# PERMIT

## SEWAGE DISPOSAL SYSTEM HOWARD COUNTY HEALTH DEPARTMENT BUREAU OF ENVIRONMENTAL HEALTH 410-313-2640

UBDIVISION Wilets LOT NUMBER A ADDRESS 1900 Long Corner Road

**PRESERVATION PARCELS A AND B**  
**"WILETS PROPERTY LOTS 1 THRU 3**  
**AND PRESERVATION PARCELS A AND B"**

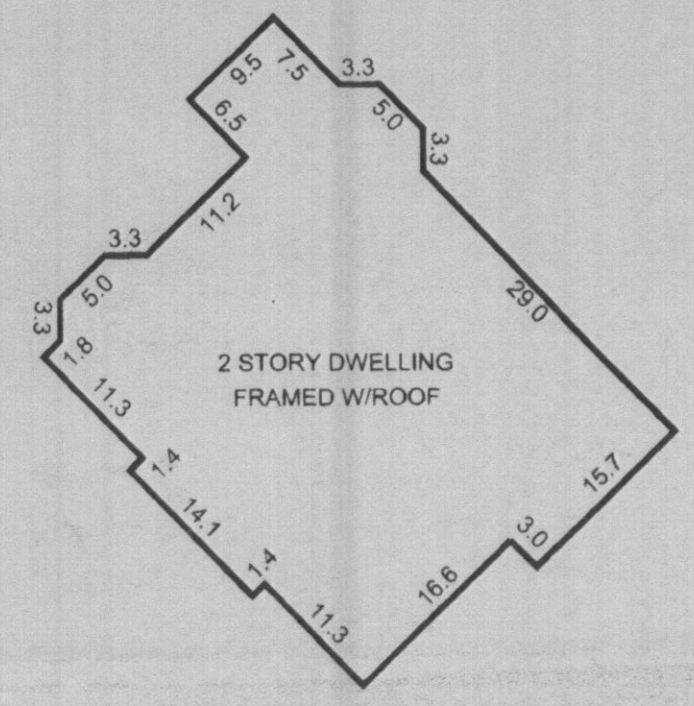
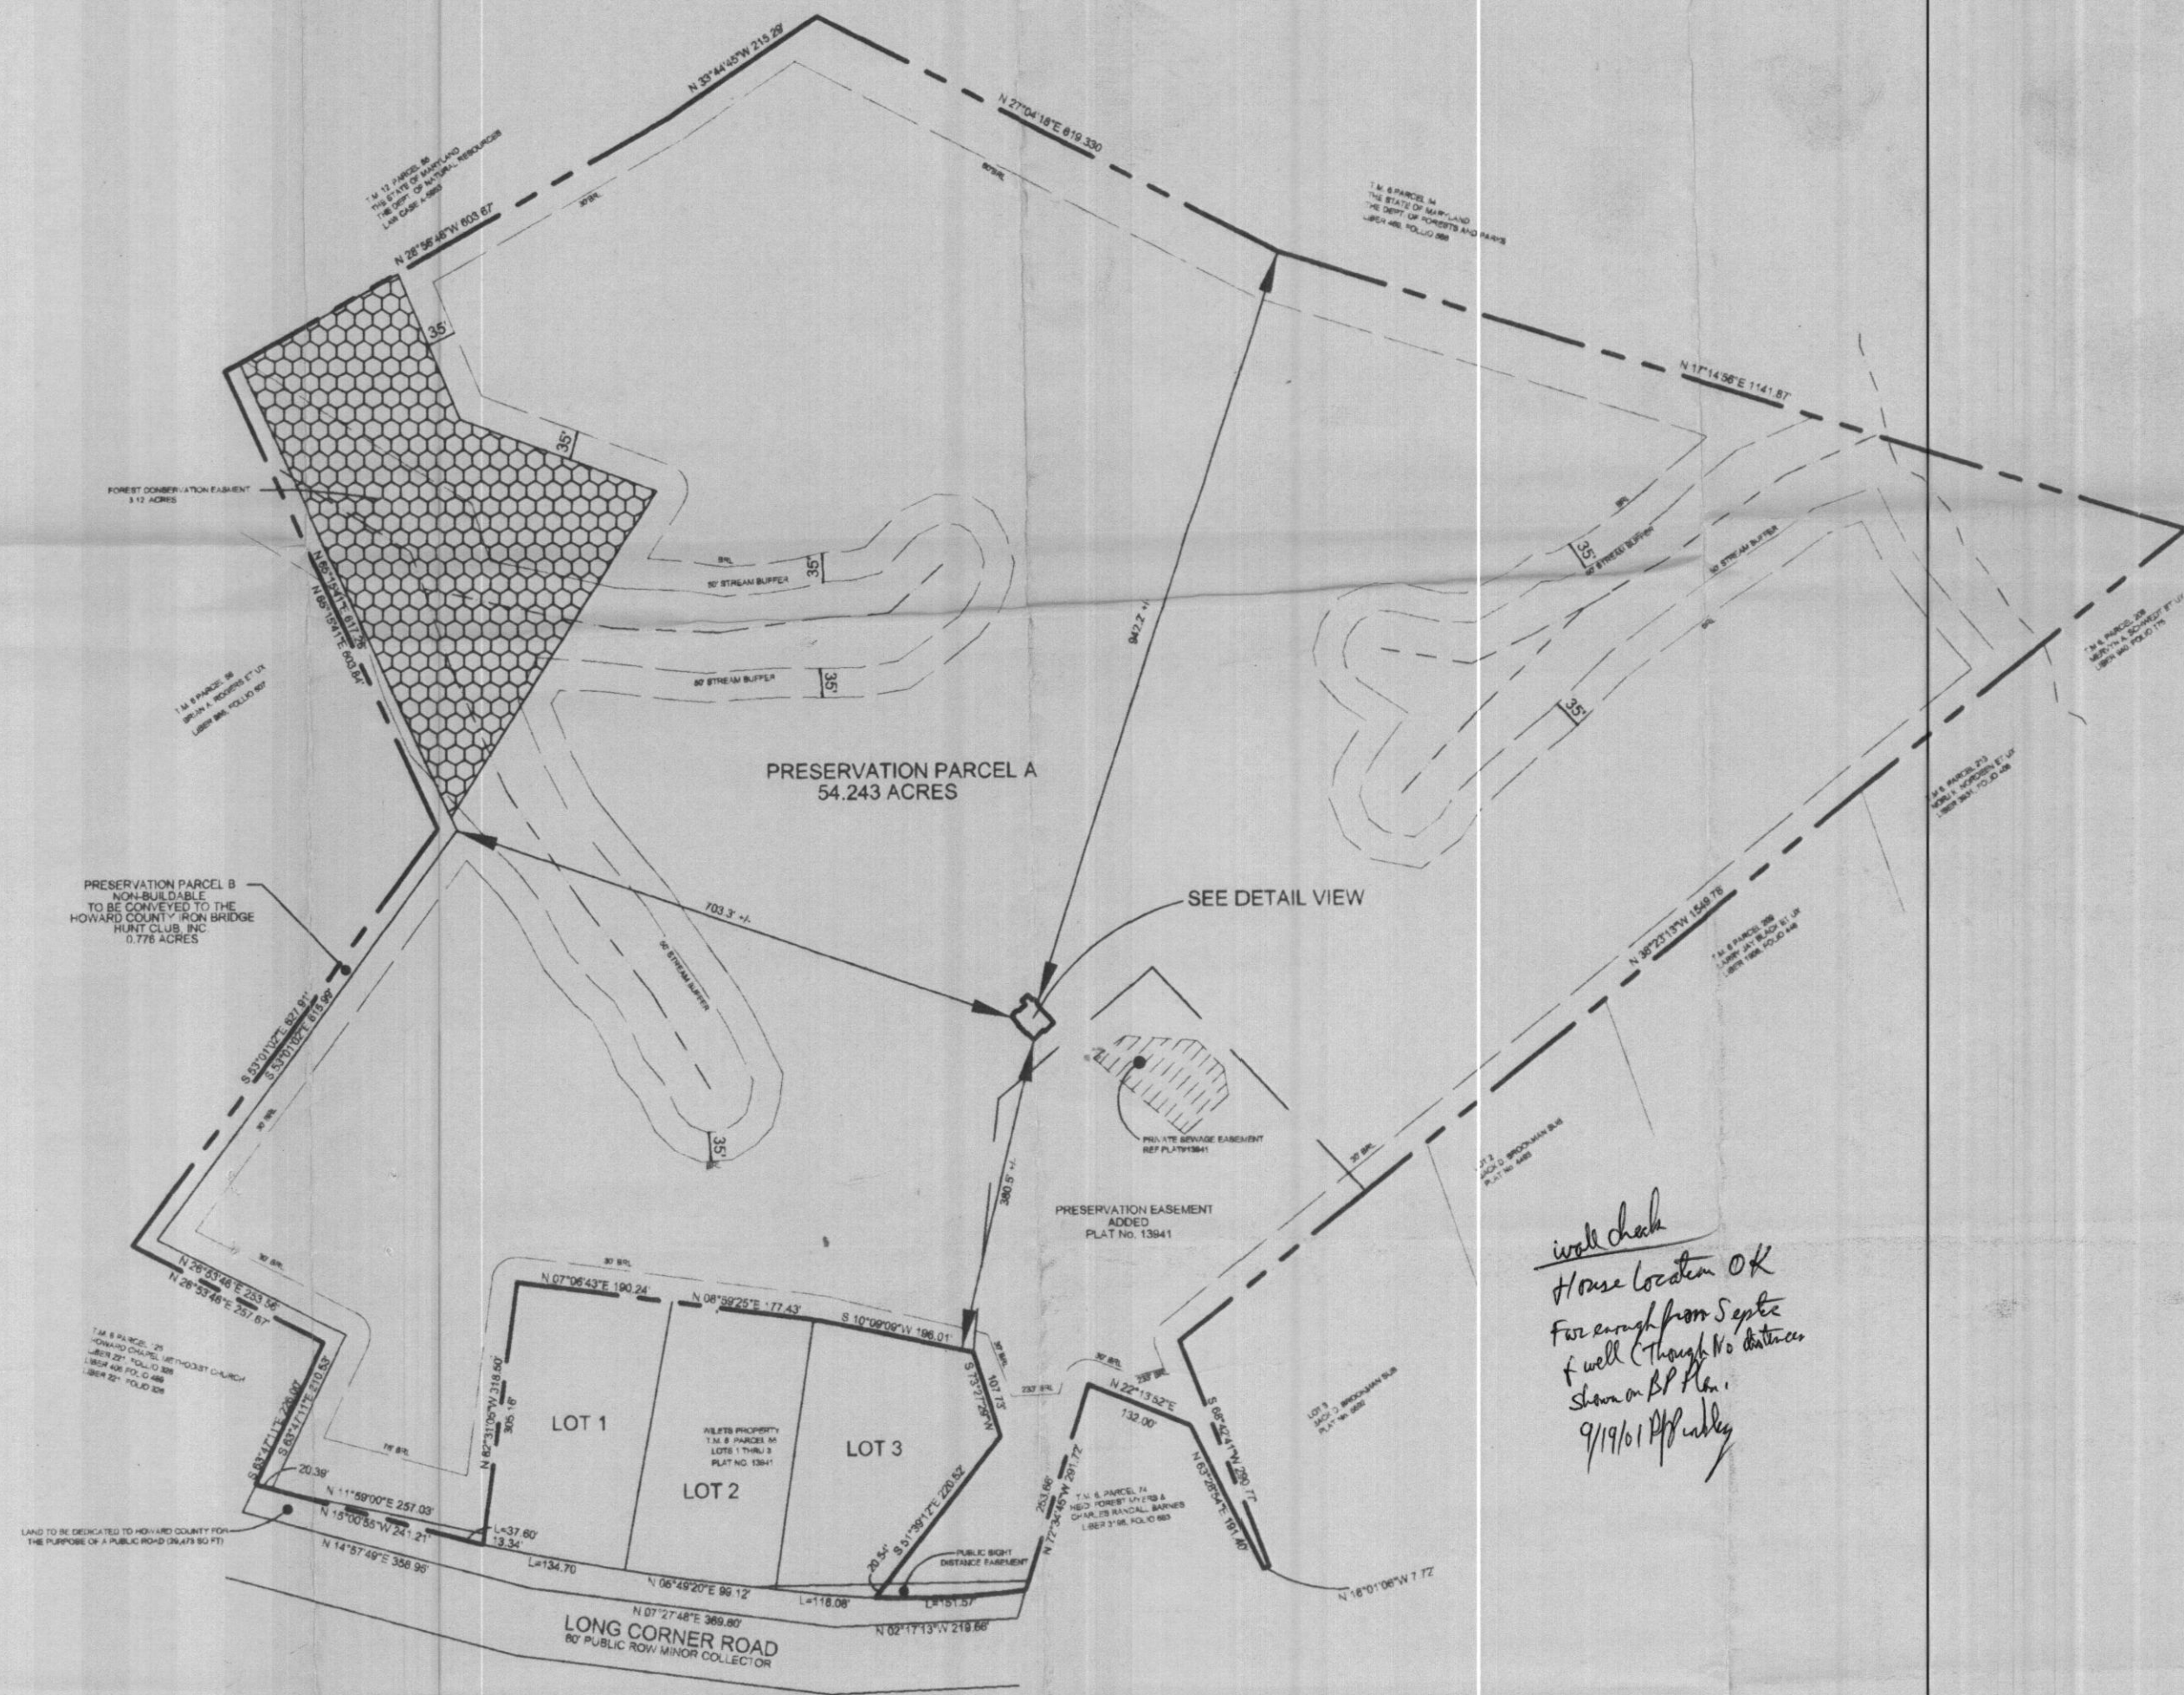
INSPECTION COMMENTS: 10/2/01. WELL LINE NOT PUT IN PER PLAN. Septic lines will have to cross well line. (BB) 10/4/01 Installer said he put septic line directly above sleeved well line. Advised him that lines were not supposed to cross and if they do, the septic line must be 12" above well line. Will accept this time. (BB) 10/9/01- ON TO COVER ALL WORK - (SRV/K6)
